Document 00 20 00 - Addendum No. 1

DATE: November 24, 2025

SE878D Meadow Lodge - HVAC and Roof Replacement
Indiana University Southeast
IU 20241304

VPS ARCHITECTURE	Issue Date: 11/21/25	Project Title: MEADOW & WOODLAND LODGE - HVAC AND ROOF REPLACEMENT - DUCT PENETRATION
Client Project No:	Referencing Drawing No:	Drawing No: ADD1-ASK1

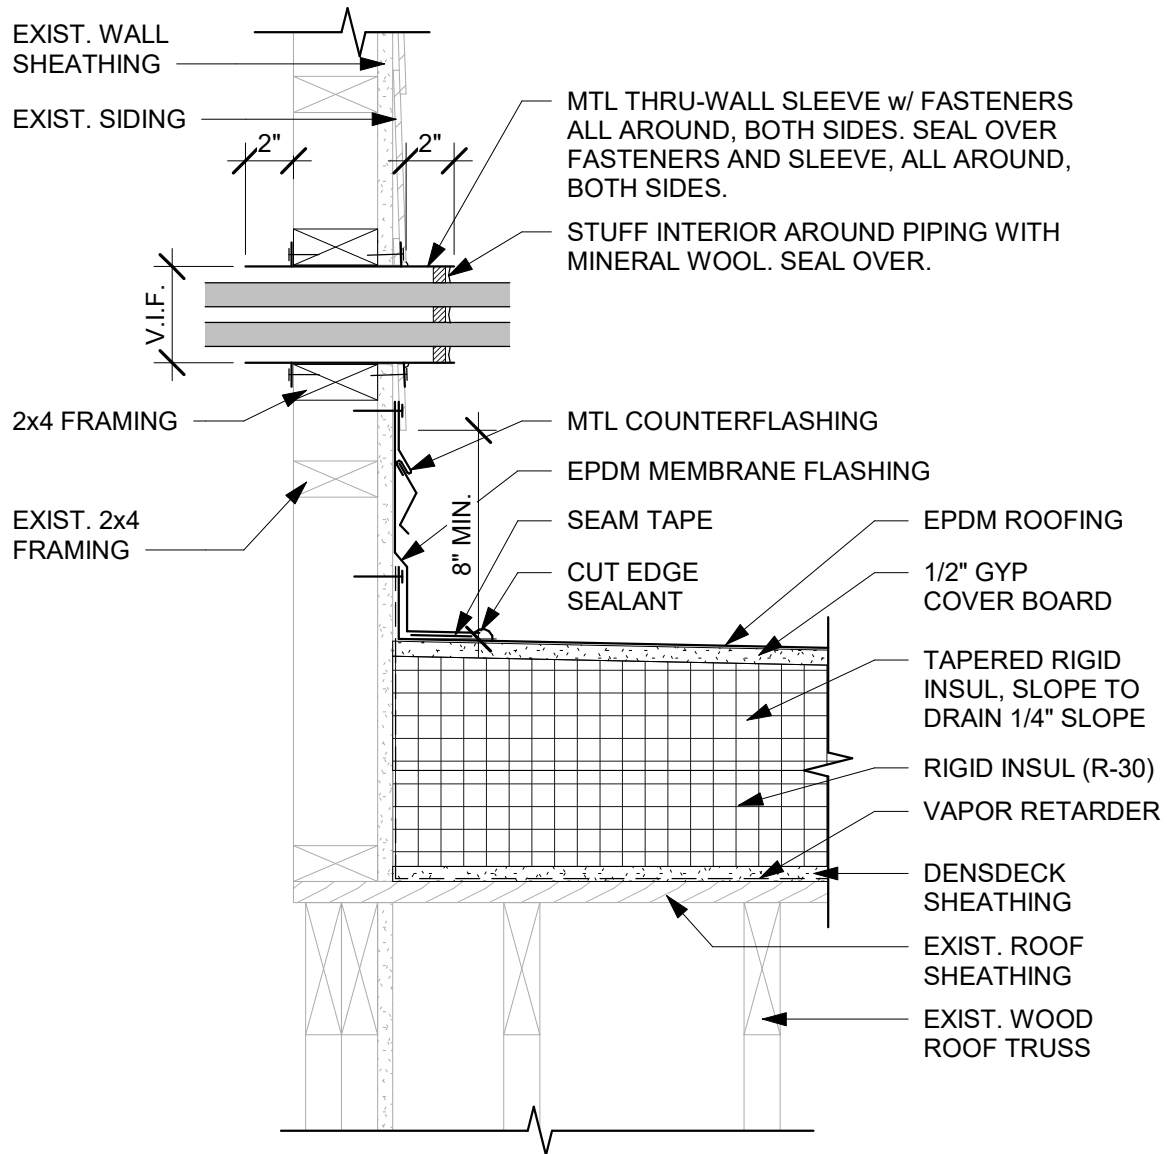
2. Sheet A001 – GENERAL PROJECT INFORMATION:
 - a. Added “DUCT PENETRATION” detail as indicated on attached sketch, ADD1-ASK1.
 - b. Added “PIPE PENETRATION” detail as indicated on attached sketch, ADD1-ASK2.

SHEET NO. G001

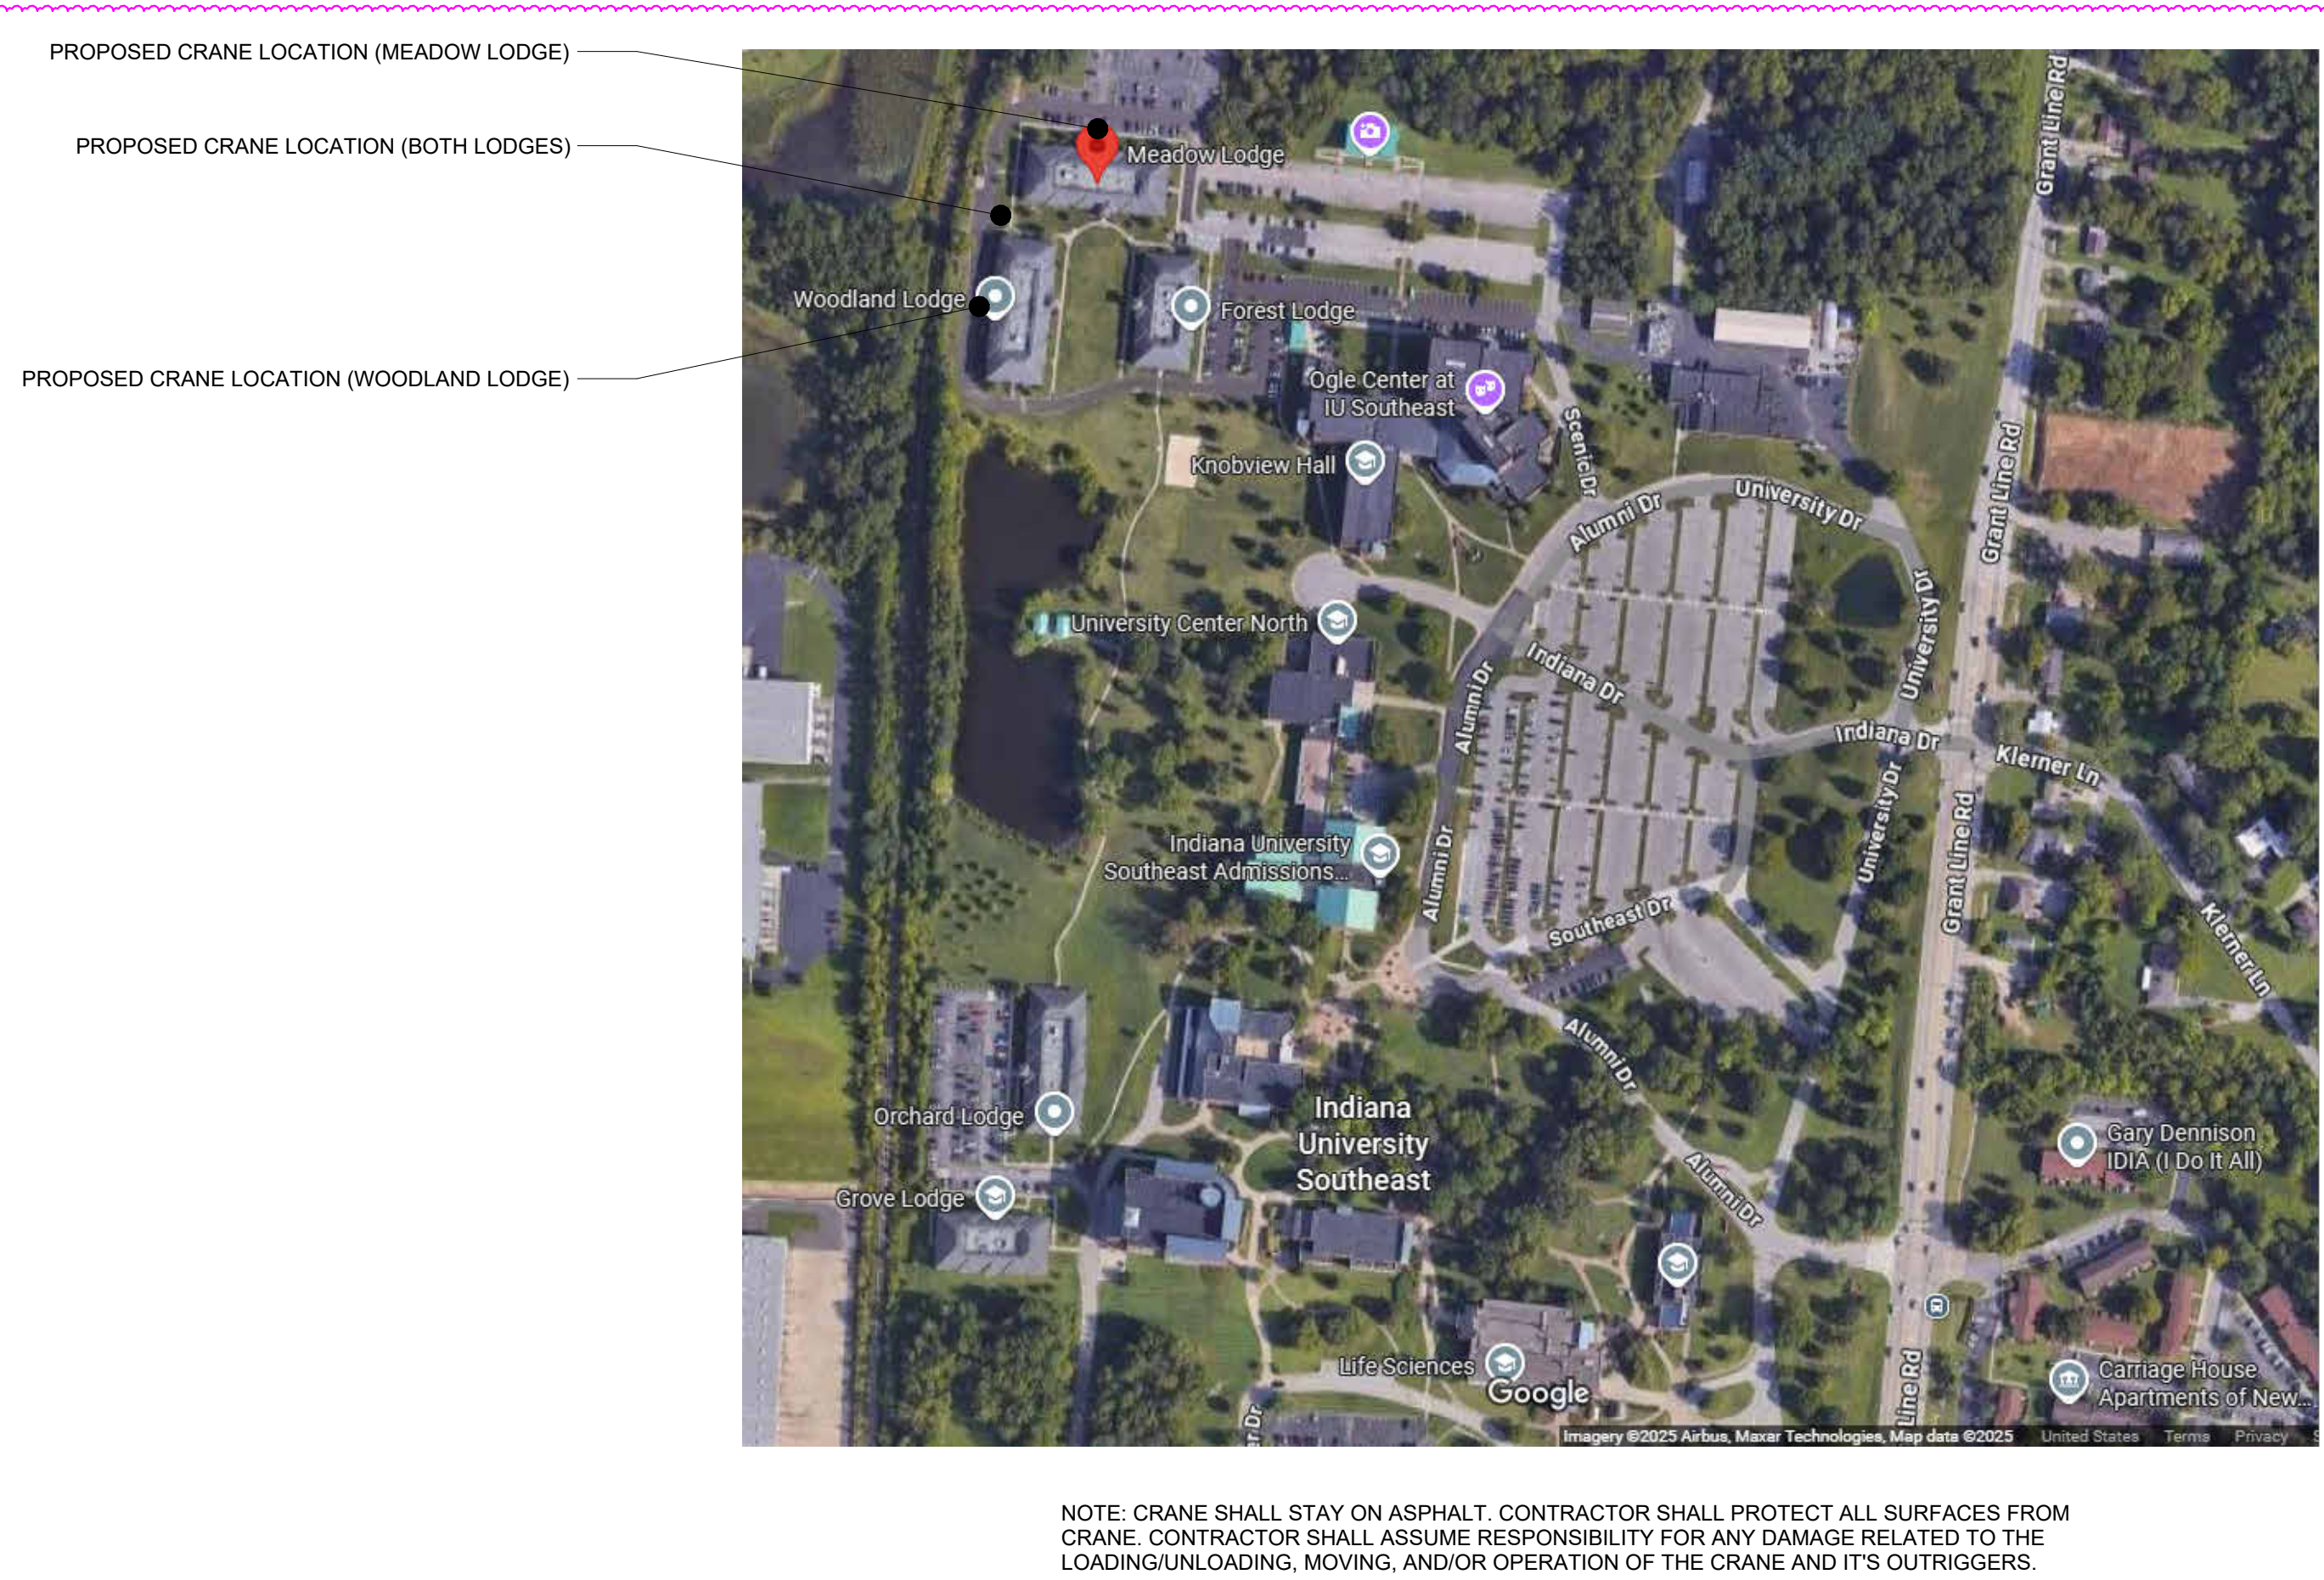
1. Sheet G001 – COVER SHEET:
 - a. Updated “VICINITY MAP” to show proposed crane locations and note as indicated on the attached.
 - b. Updated “PROJECT PHASING” as indicated on the attached.

2 SECOND FLOOR MECHANICAL DEMOLITION PLAN
MD101 SCALE: 1/8" = 1'-0"

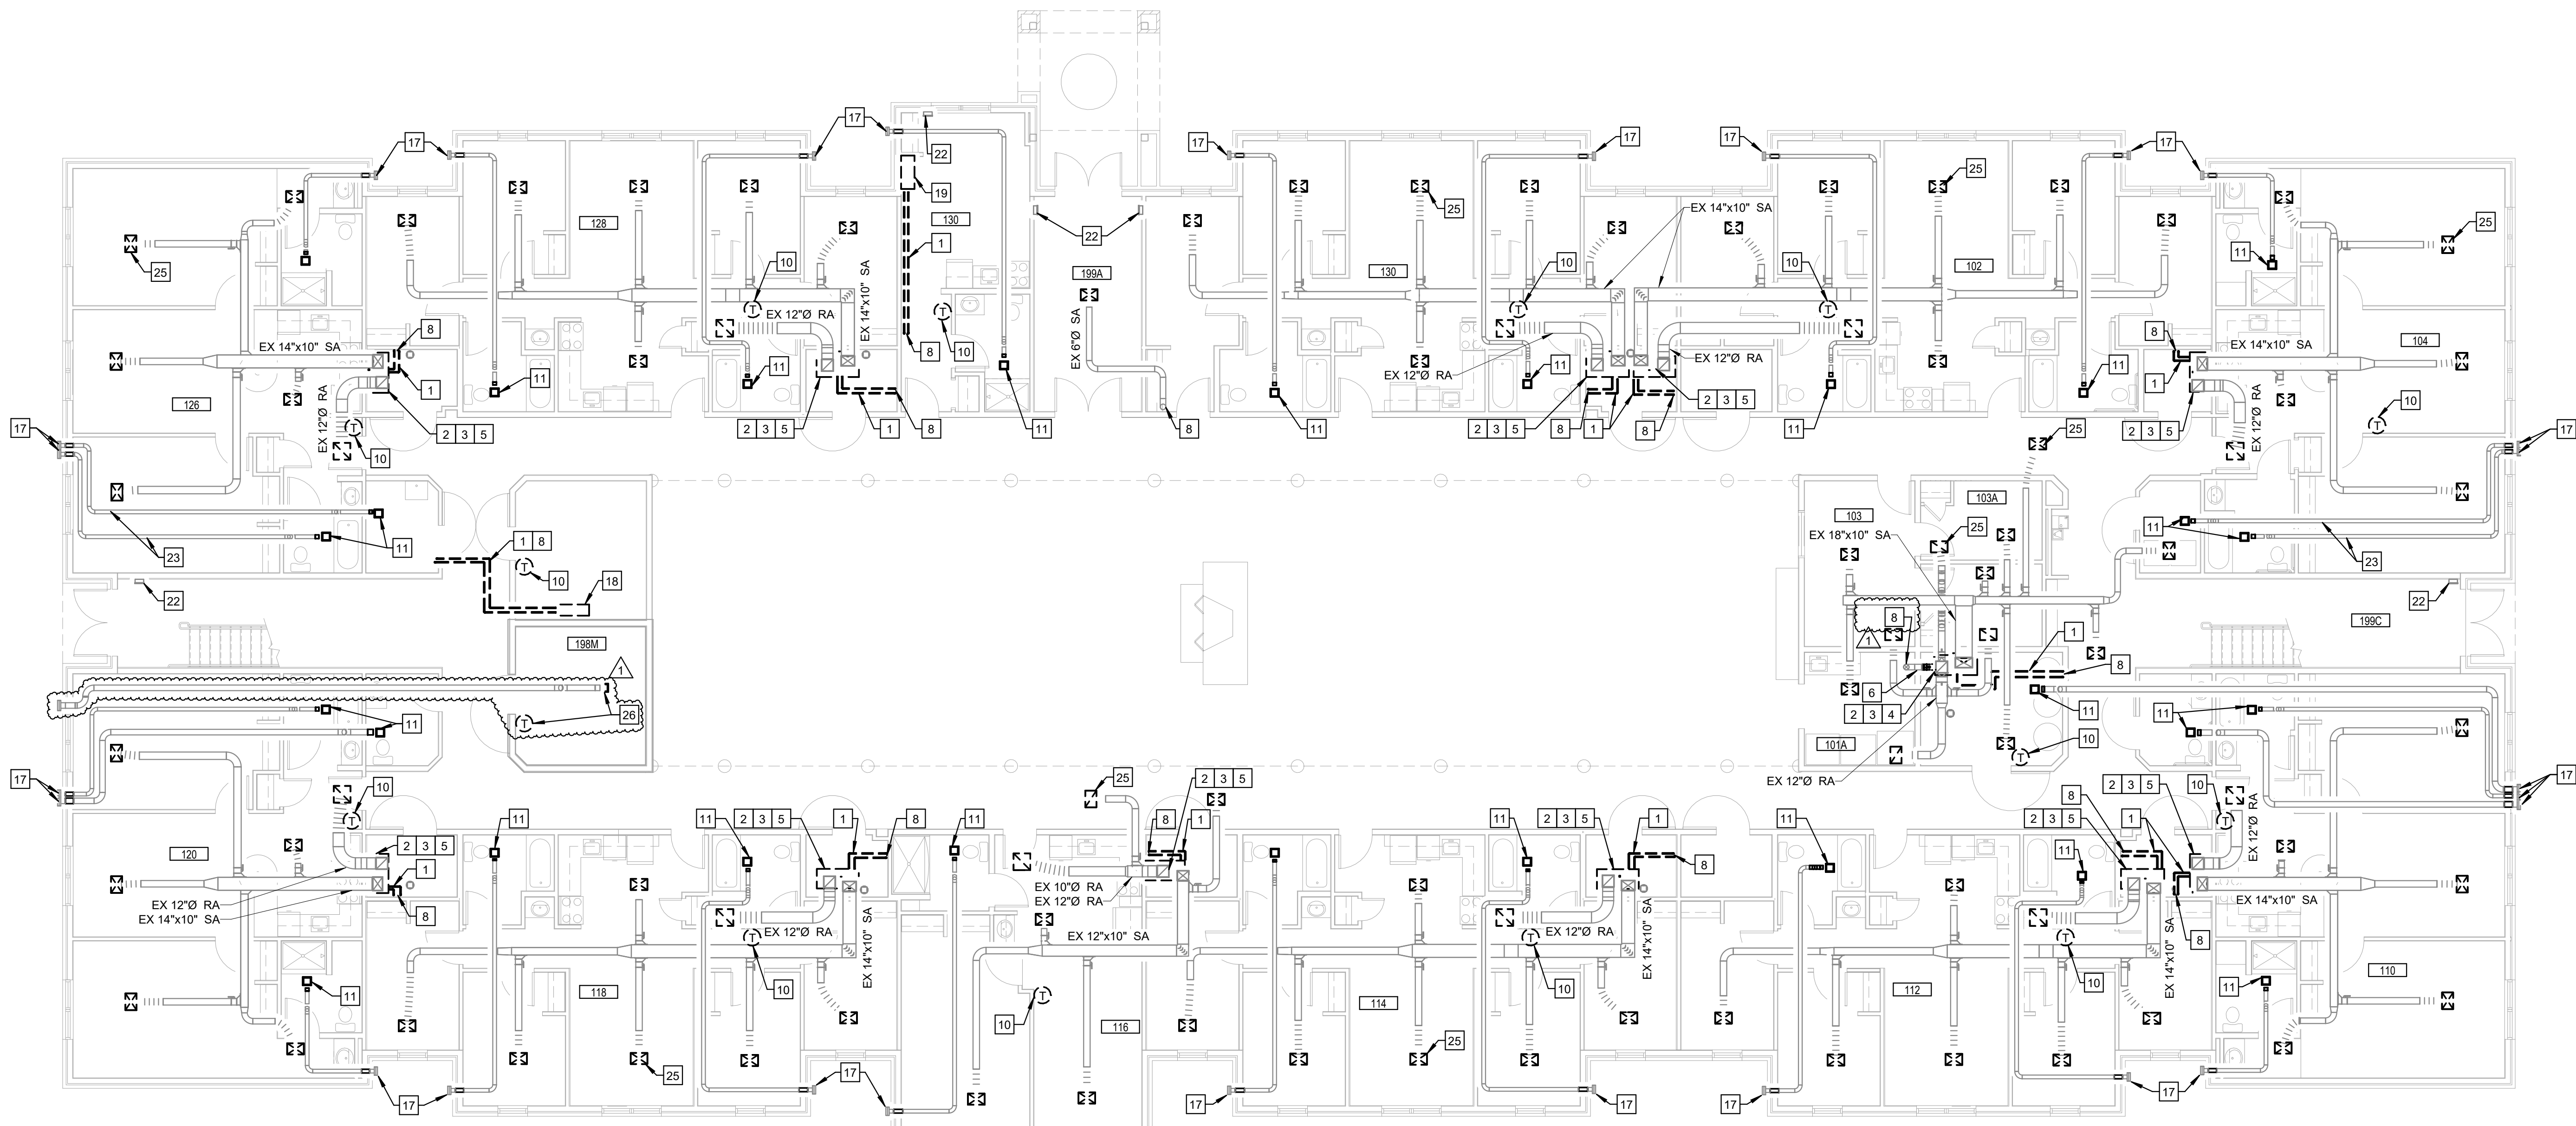
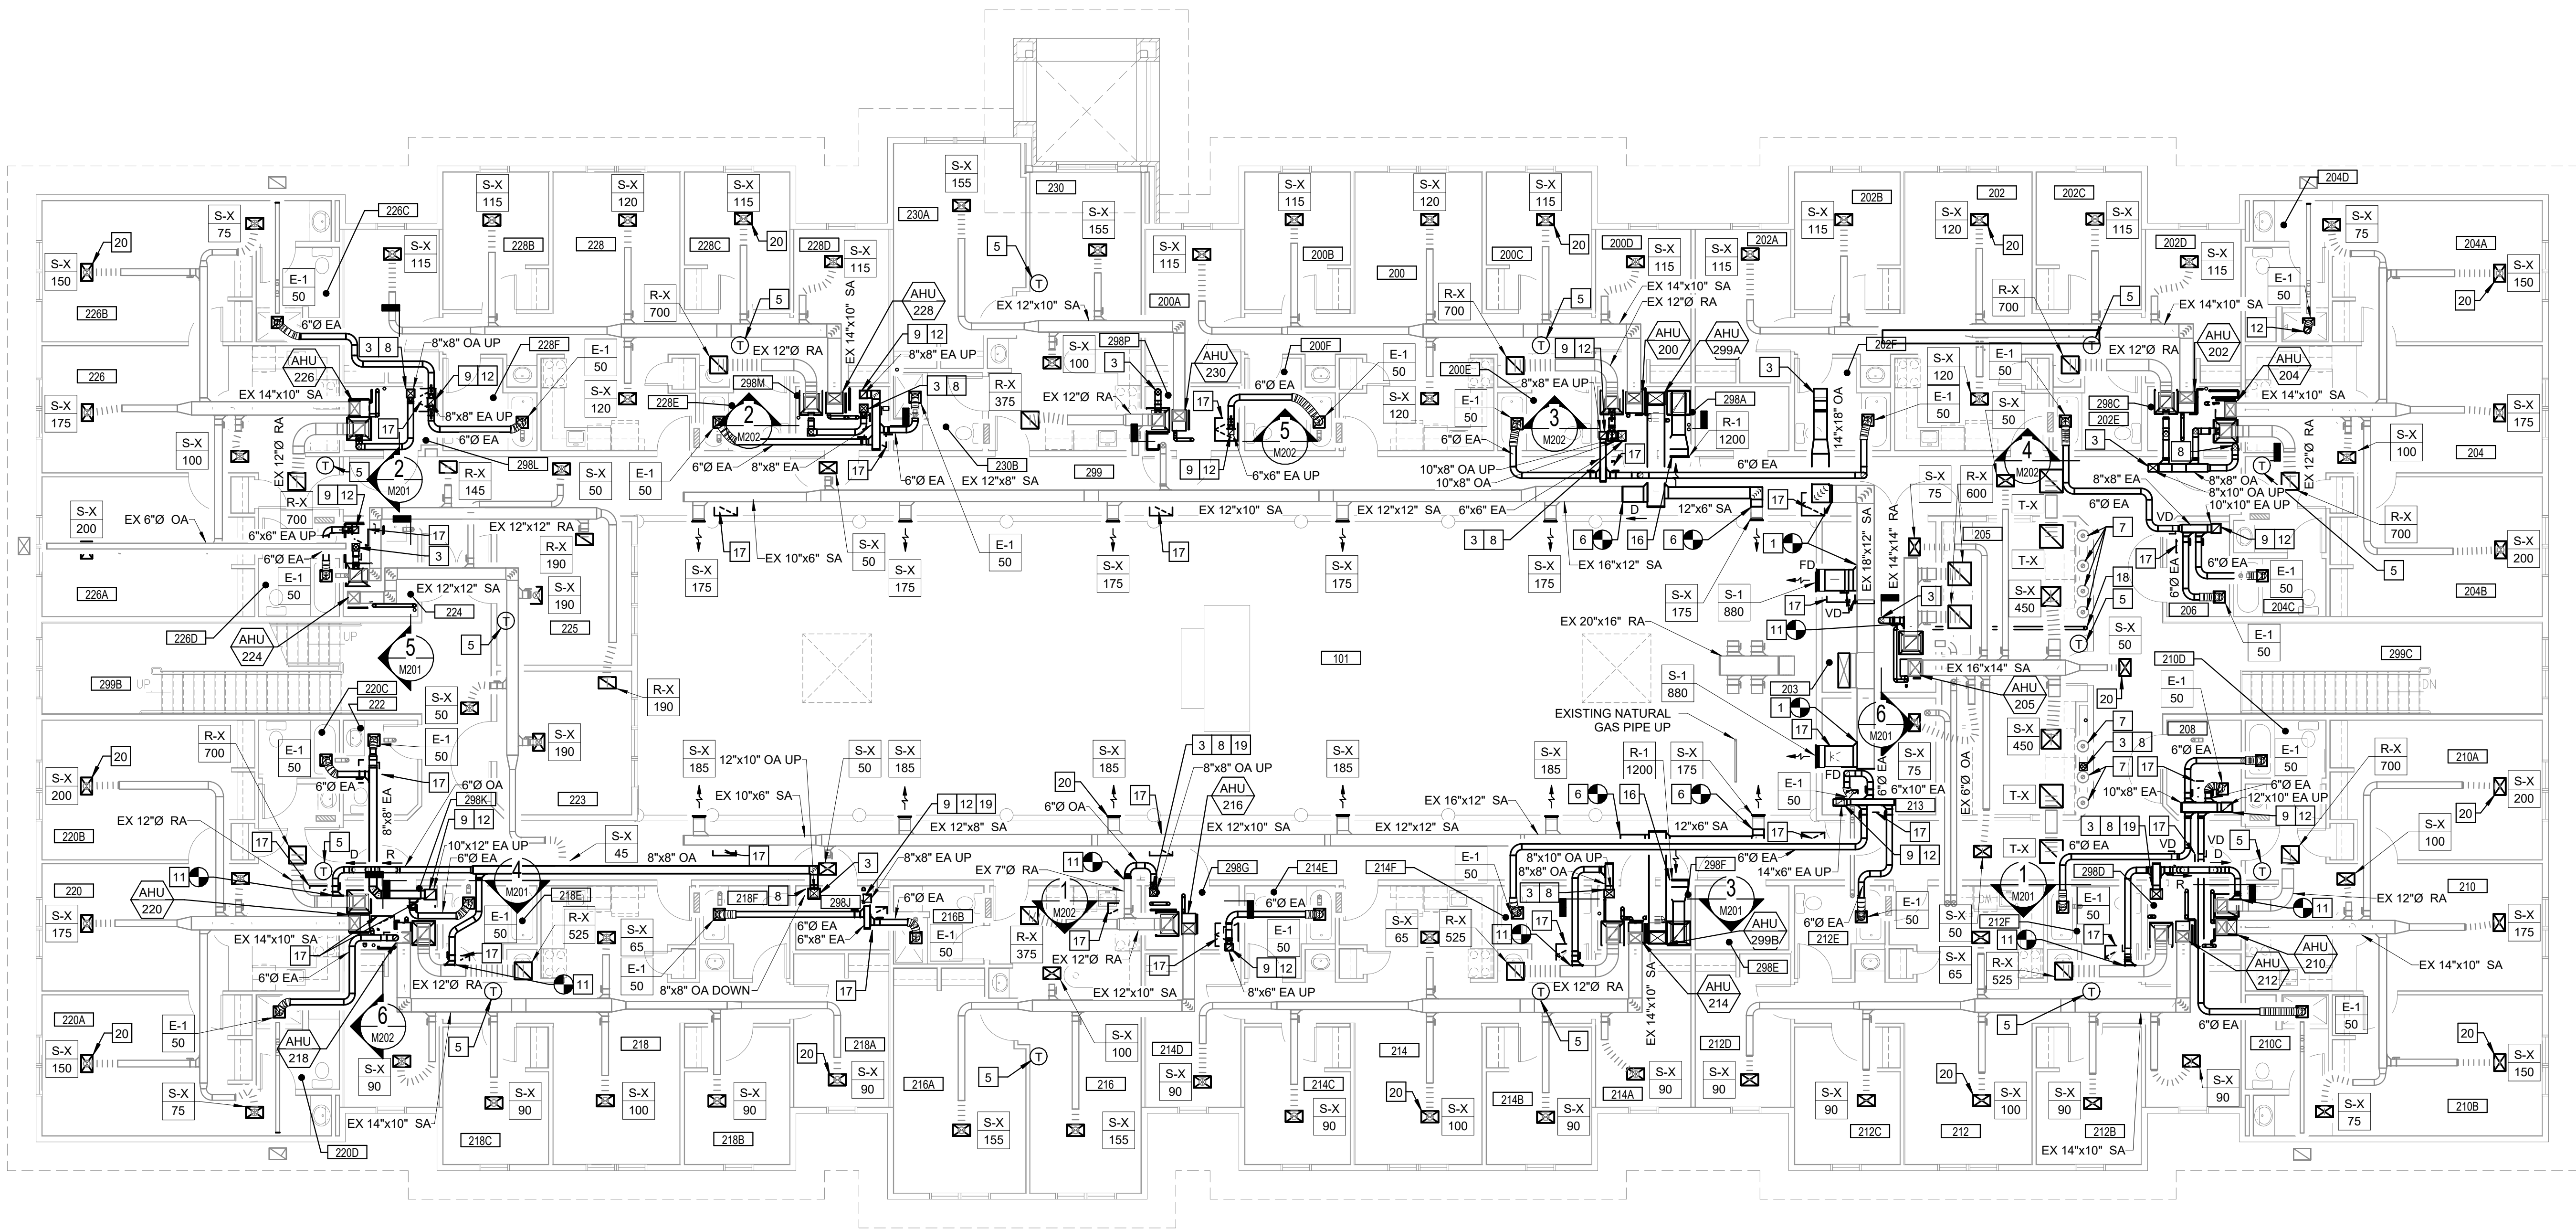
3. Sheet MD101 – MECHANICAL DEMOLITION PLANS:
 - a. Added Keyed Note 26 as indicated on the attached.
 - b. Modified Keyed Notes in room Electrical Room 198M as indicated on the attached.

- c. In room 103, Keyed Note 13 was deleted as indicated on the attached.
 - d. Modified Keyed Note 10 as indicated on the attached.
4. Sheet M101 – MECHANICAL PLANS:

- REMOVE EXISTING EXHAUST FAN AND ASSOCIATED LINE-VOLTAGE THERMOSTAT. PREP EXISTING DUCTWORK FOR NEW EXHAUST FAN. SEE NEW WORK.
